SVC – 021312: Feb 13, 2012
York Variable Speed Air Handlers

SERVICE BULLETIN

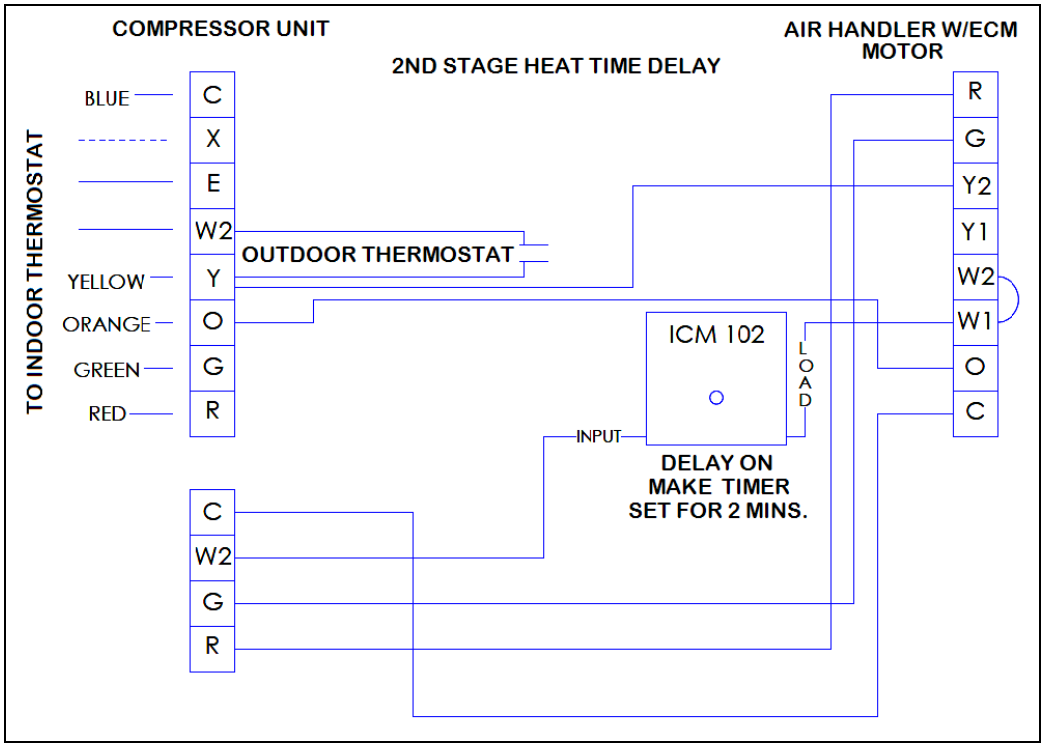
In some EarthLinked® Heating and Cooling System installations utilizing the York variable speed air handler, when the system is operated in heat mode and the thermostat set point is raised enough to call for two stages of heat, in some cases there is no time delay between activation of the compressor (Y2) and auxiliary heat (W2), with the result that the blower does not come on.

This situation can be corrected by field installing a delay-on-make timer at the W2 connection as shown in the following illustration. The time delay should be set for 2 minutes. A Mars model #32391 or equivalent timer is recommended, available at HVAC distributors and wholesalers.
